**Change Order No.** 1

| Project: | **Sanitary Sewer System Rehabilitation** | Contract Name: Sanitary Sewer System Rehab. | |

**Description**: This change order is for items discussed during the Pre-Construction Conference, including the replacement of a 4" water main that was in direct conflict with the installation of Line S-9, additional camera inspection of 6300 LF of sewer line for consideration of replacement, and a forcemain replacement at the railroad crossing for Line FM-1.

STA 0+00 TO STA 4+04
LINE S-9

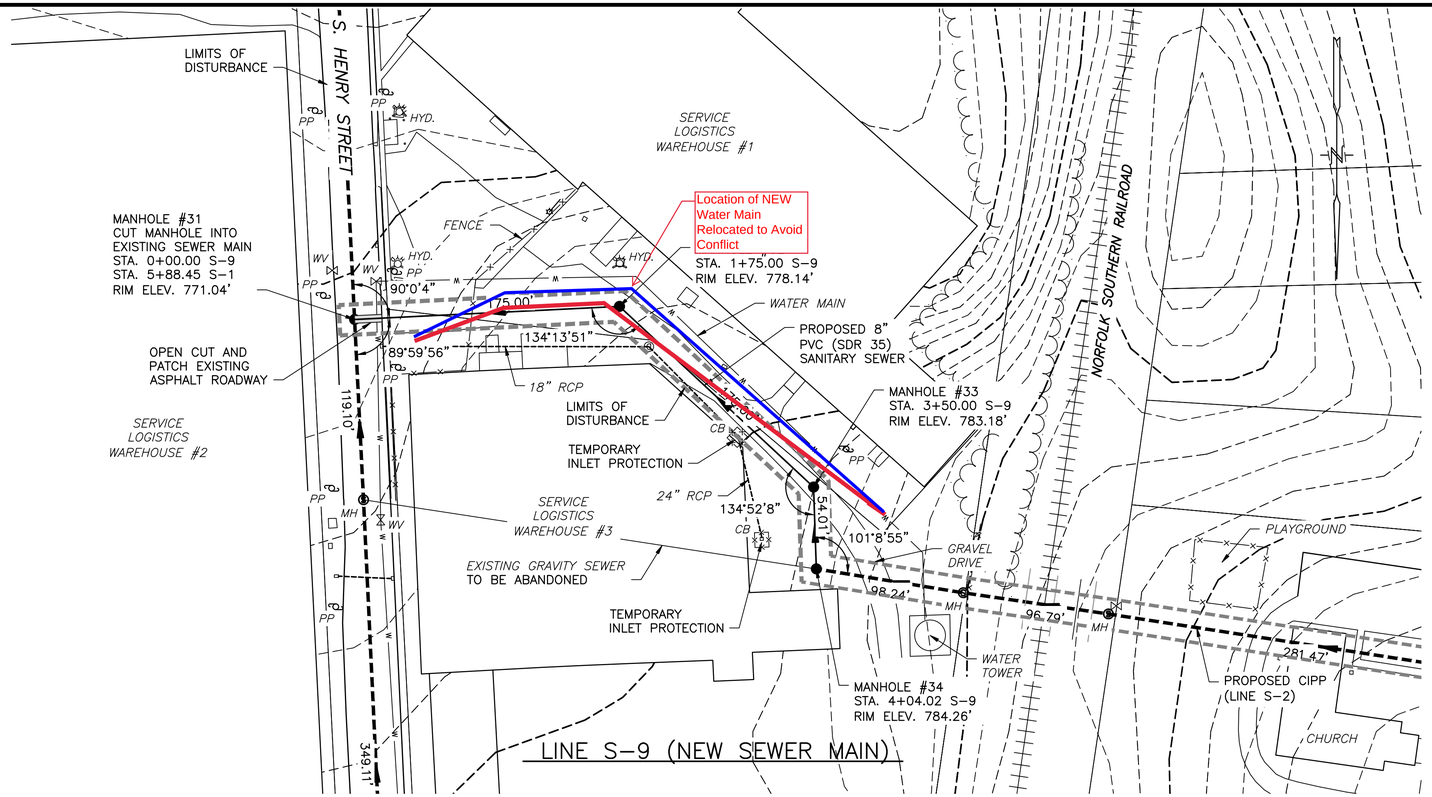
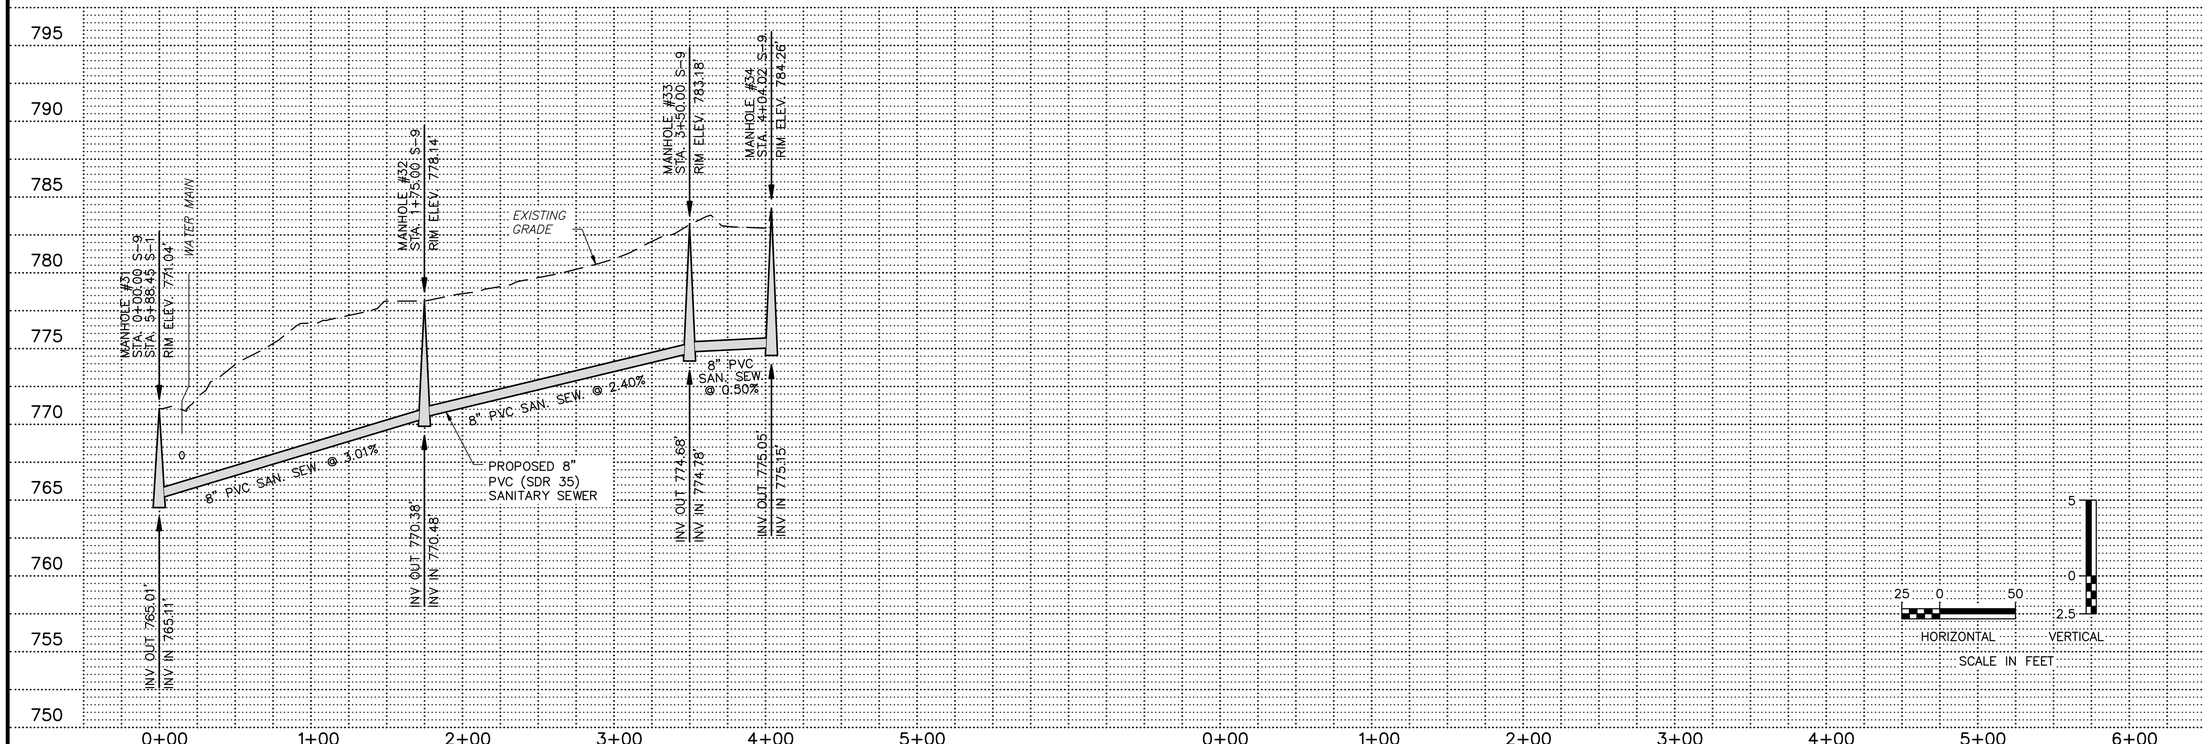
| **Water Main Replacement at Conflict with Line S-9 Installation** | | | |

| **Water Main Replacement at Conflict with Line S-9 Installation** | | | |
|---|---|---|---|
| 4" PVC SDR 21 Water Main (Night Installation) | 502 LF | $28.00 | $14,056.00 |
| Tapping Sleeve and Valve Connection | 1 EA | $4,500.00 | $4,500.00 |
| 2" Service Reconnection | 1 LS | $1,500.00 | $1,500.00 |
| Terminate Old Line Tap and Connections | 1 LS | $1,000.00 | $1,000.00 |

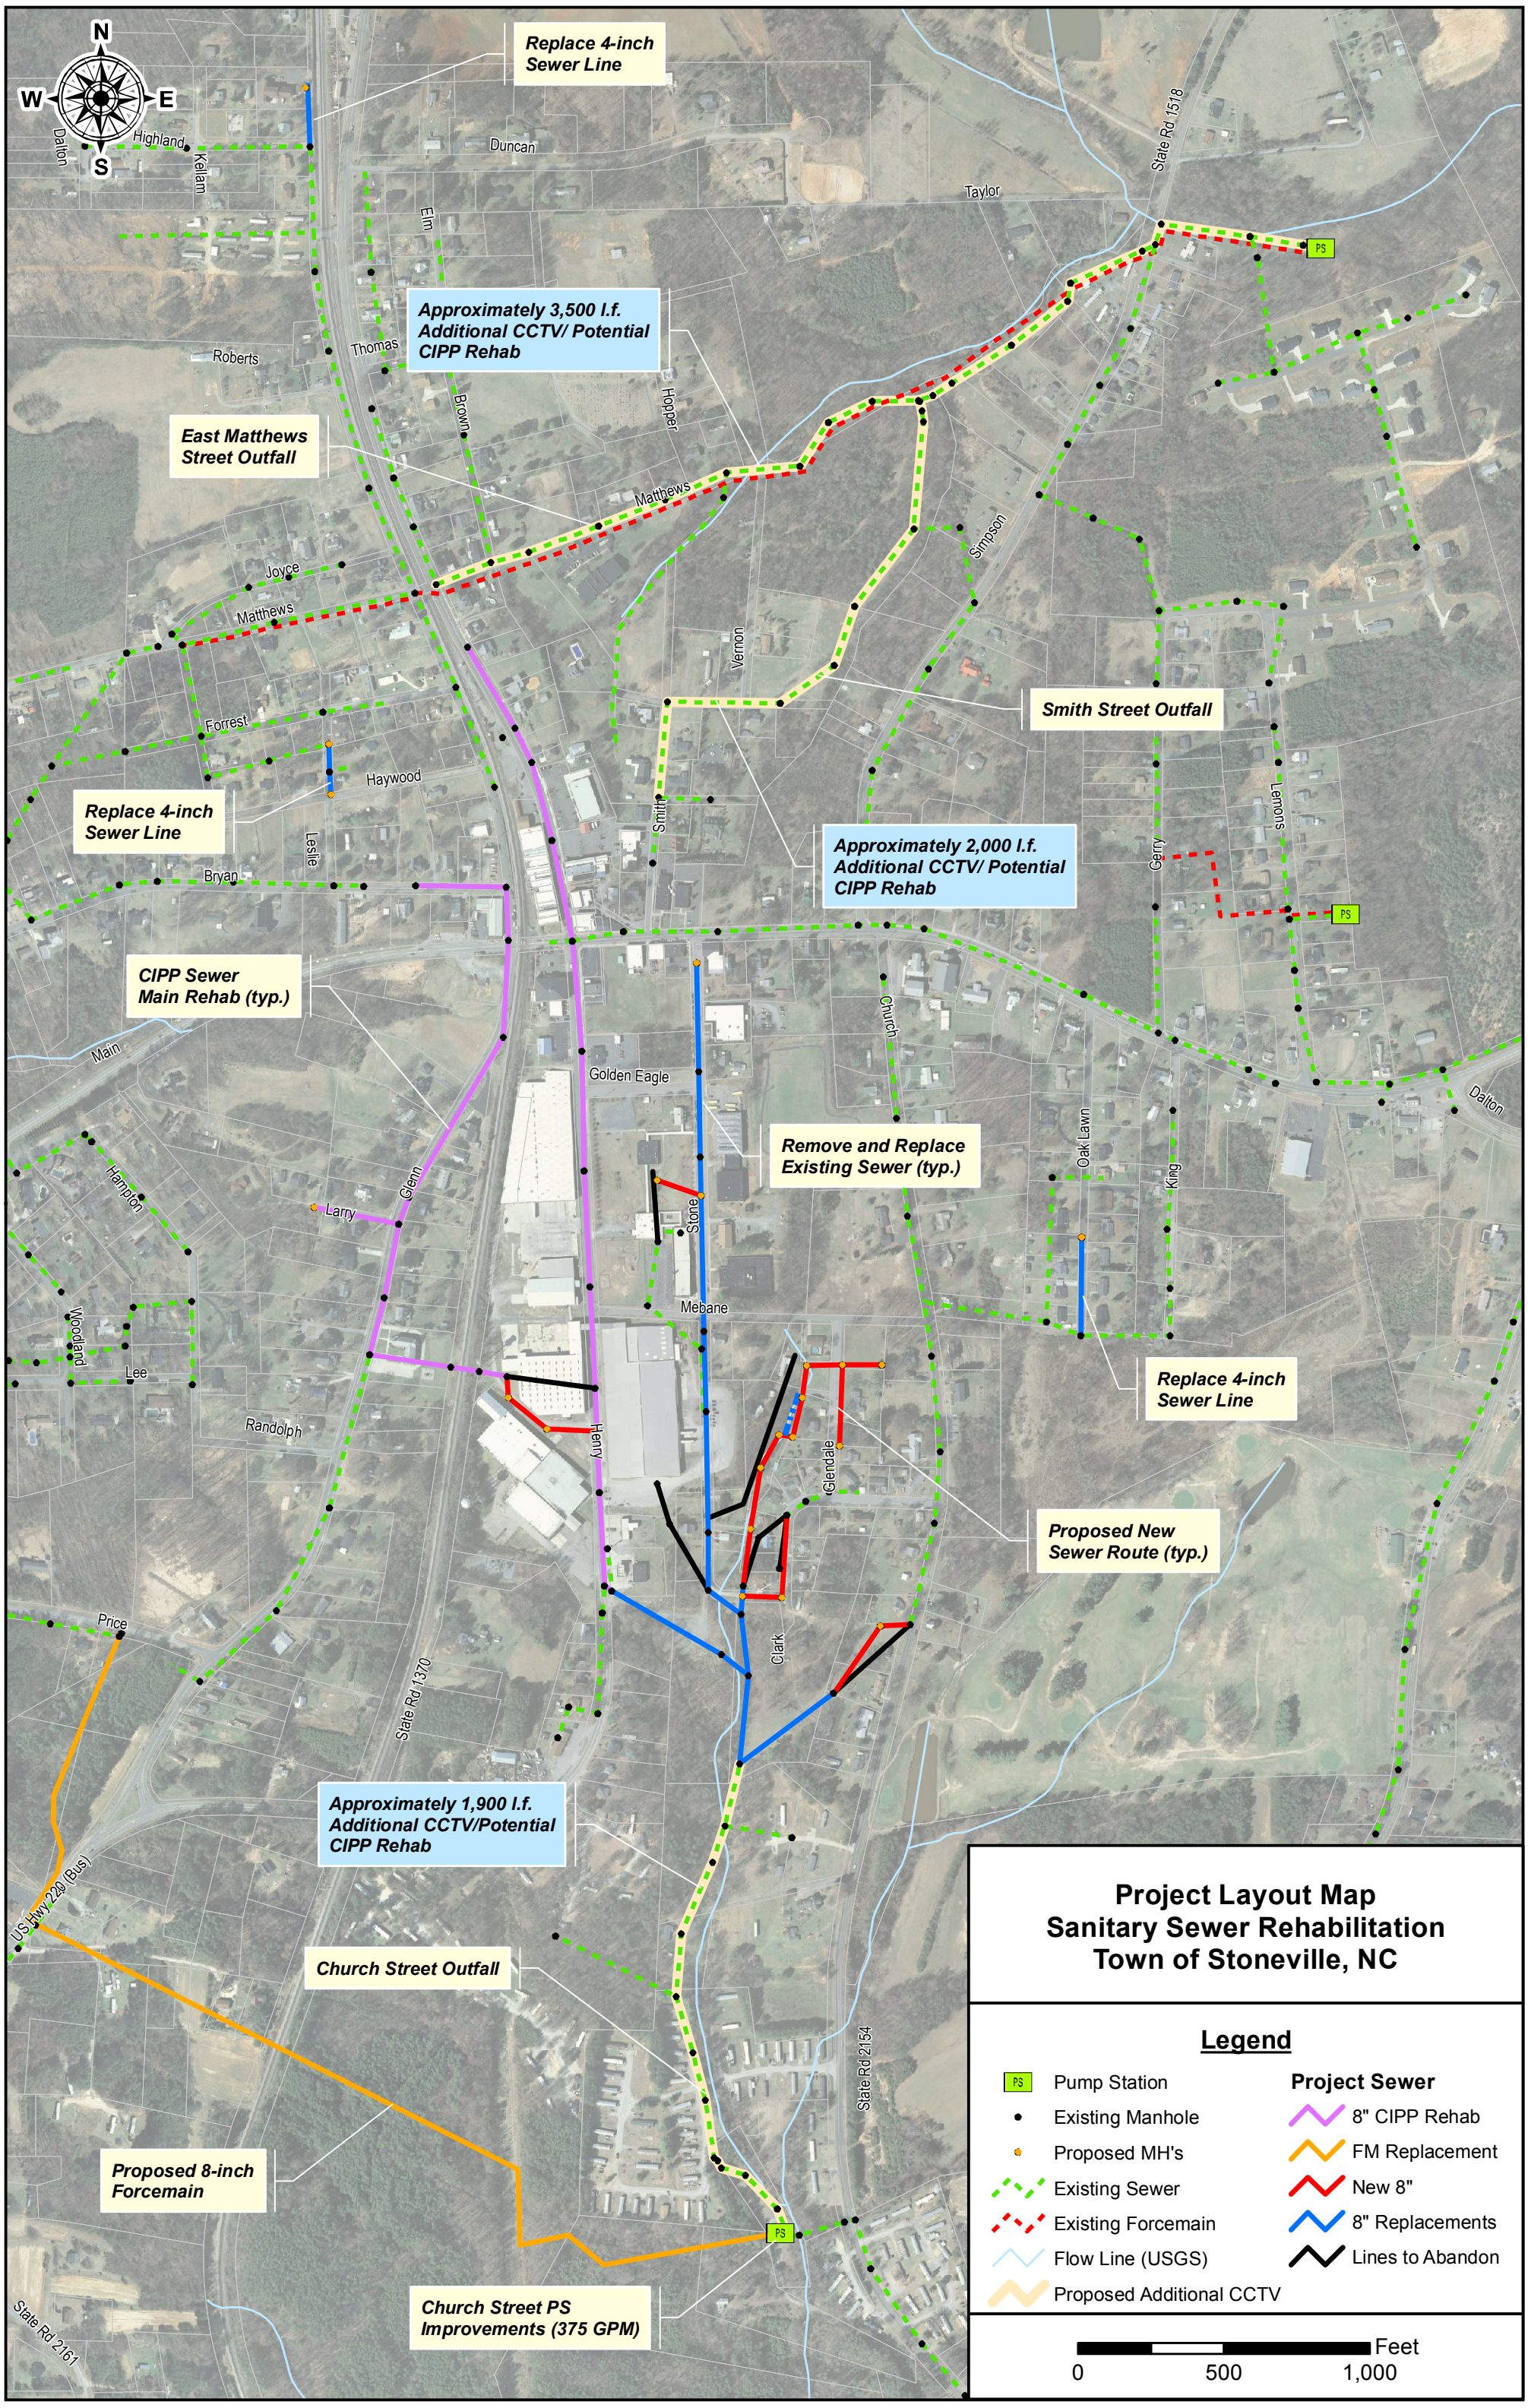
| **East Matthews Street Outfall** | *Qty* | *Unit* | *Unit Price* | *Total Price* |

| **Church Street Outfall** | *Qty* | *Unit* | *Unit Price* | *Total Price* |

| **Smith Street Outfall** | *Qty* | *Unit* | *Unit Price* | *Total Price* |

STA 19+50 TO STA 23+00
LINE FM-1

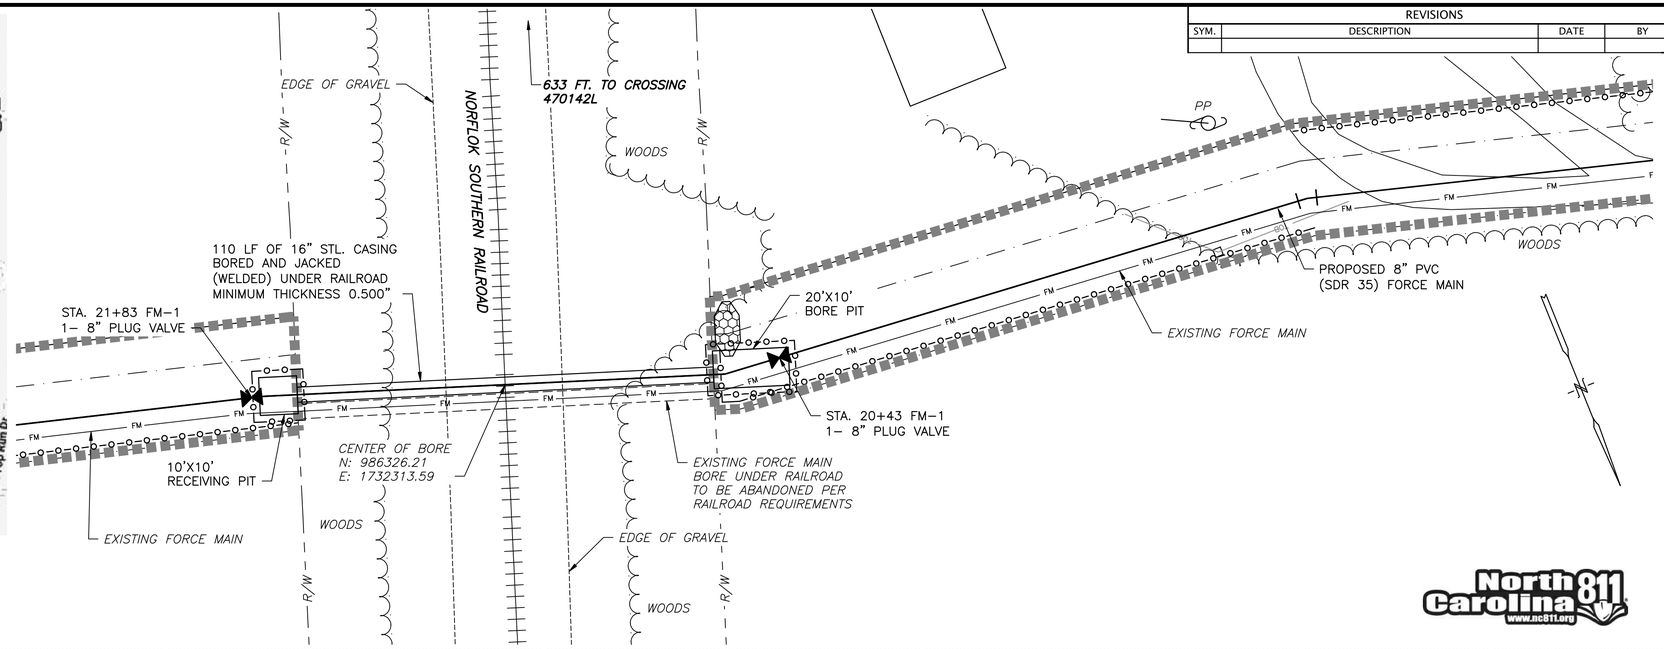
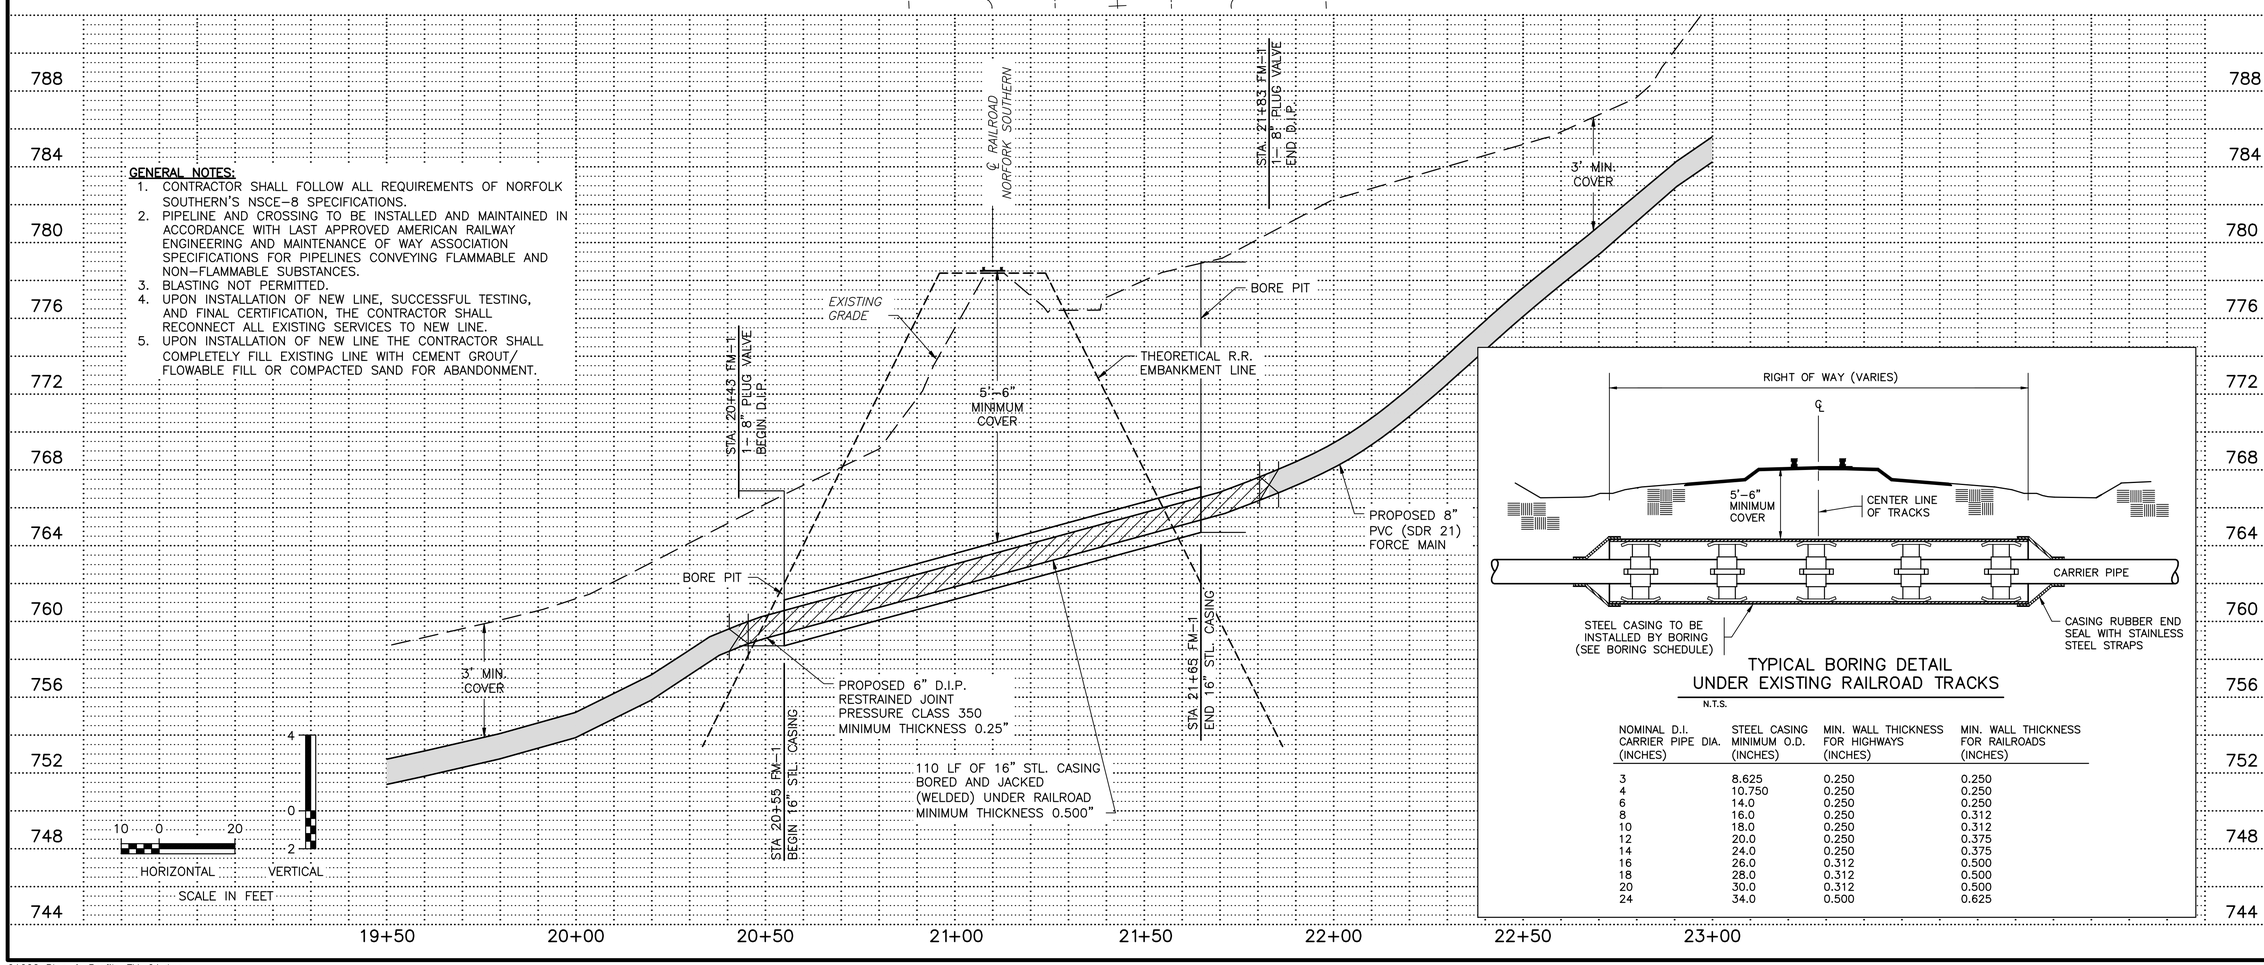
| **Force Main at Railroad Crossing** | *Qty* | *Unit* | *Unit Price* | *Total Price* |

| **Force Main at Railroad Crossing** | *Qty* | *Unit* | *Unit Price* | *Total Price* |
|---|---|---|---|---|
| New 16" Steel Casing (Bore & Jack) | 110 | LF | $250.00 | $27,500.00 |
| 8-Inch DIP Force Main | 110 | LF | $90.00 | $9,900.00 |
